**STAFF RECOMMENDATION**

**Warner Parks Historic Landmark, Hwy 100, (1221 Forrest Park Drive)**

**April 16, 2014**

**Application:** New construction-infill  
**District:** Historic Landmark Zoning Overlay  
**Council District:** 24  
**Map and Parcel Number:** 14300002500  
**Applicant:** Matthew Cramer/ Lose & Associates, Inc.  
**Project Lead:** Robin Zeigler, robin.zeigler@nashville.gov

SHEET TITLE  
**SITE LAYOUT PLAN**

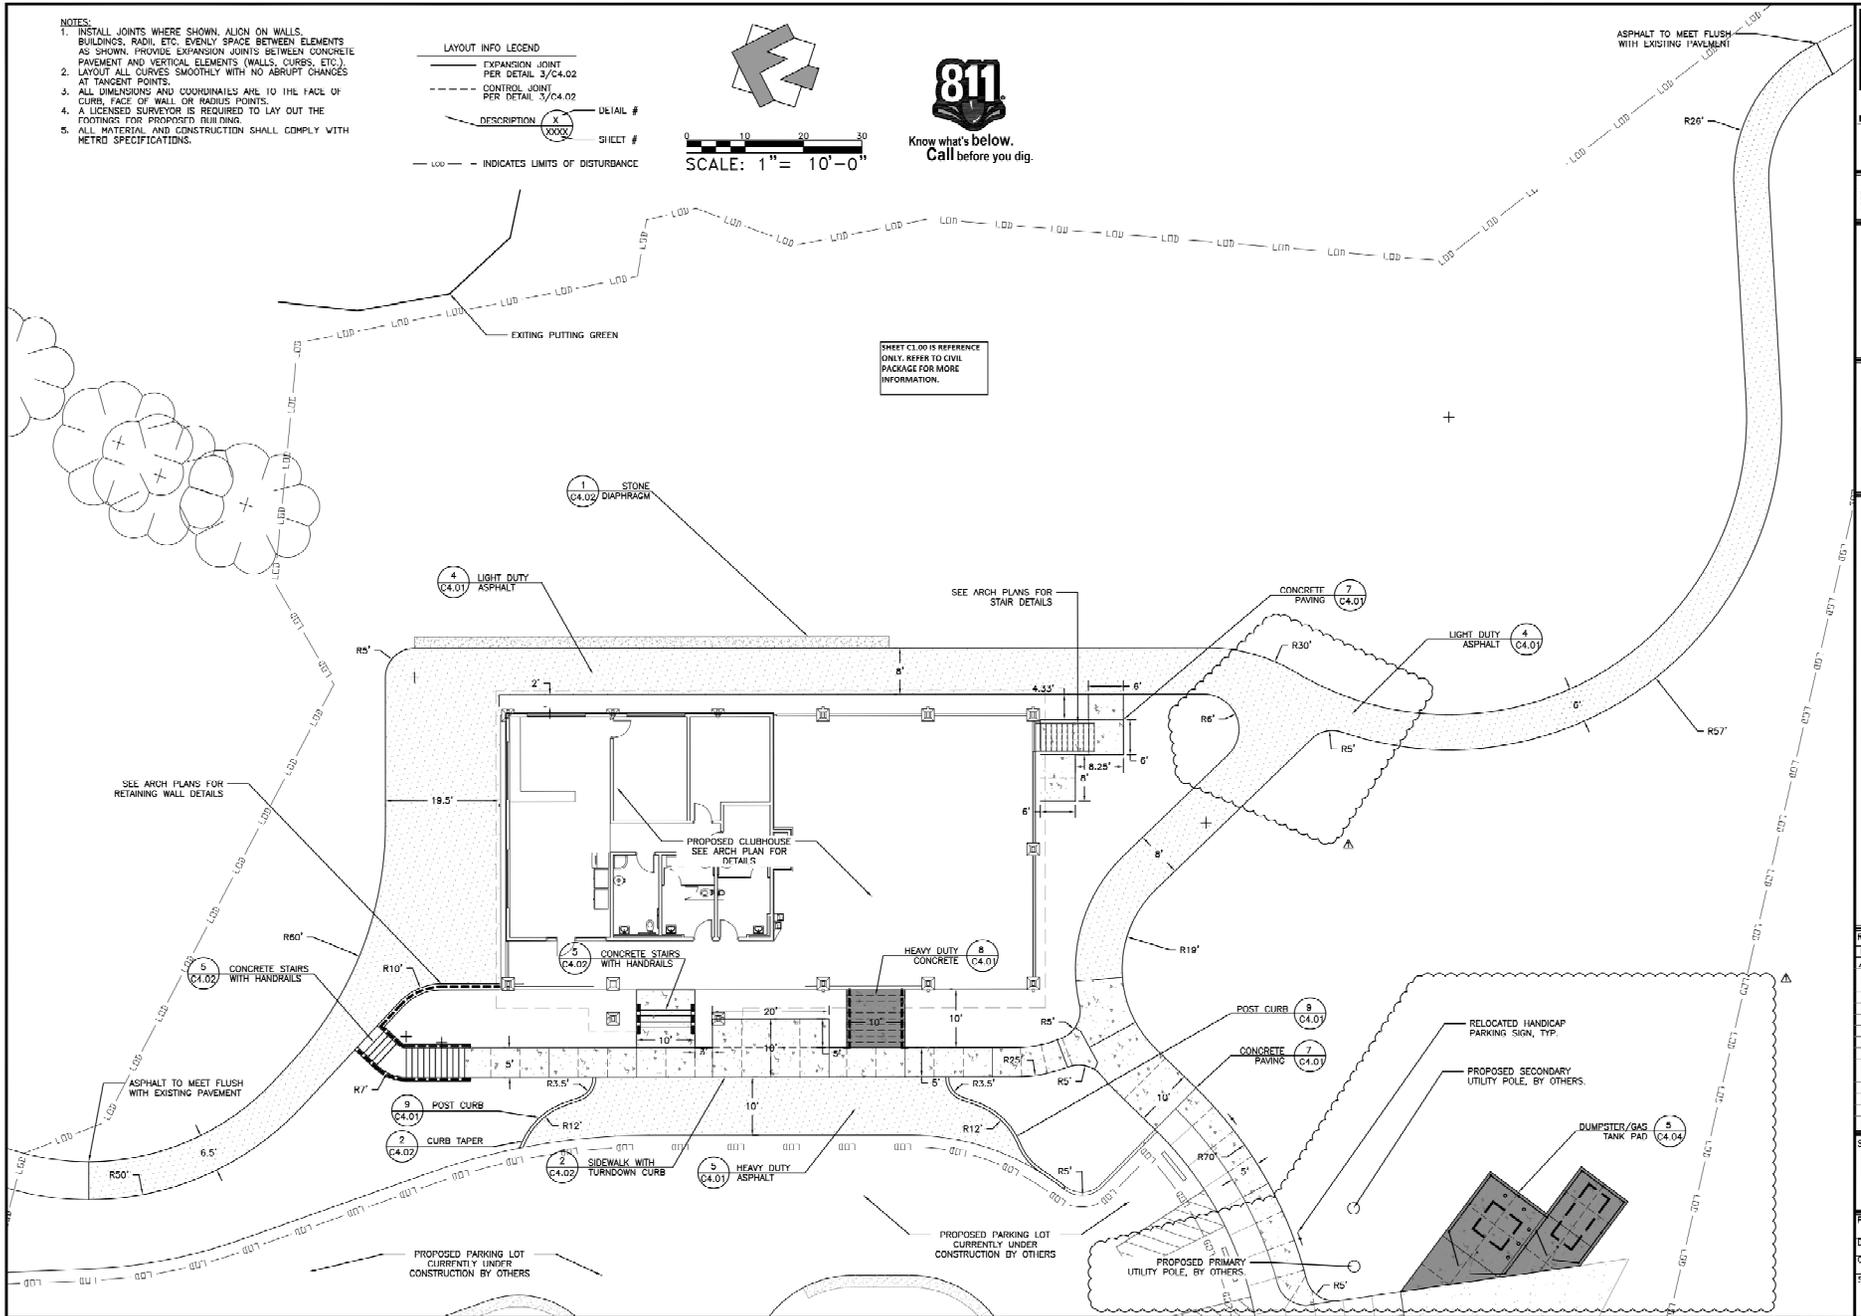
Guideline 4 requires that a new building not detract from the landmark. In this case, the building is planned to be on the opposite side of the golf course from the historic areas of Warner Park. It will likely not be visible from the historic areas of the park, except at a great distance and during the fall and winter. The project meets section II.4 and 5

There is no concern about disturbing archaeological or natural features since the clubhouse takes the place of a previous building. Construction is not expected to conflict with design guideline II.6.

Staff recommends approval of the new Percy Warner Golf Clubhouse as the project meets all guidelines for new construction at a Landmark site.
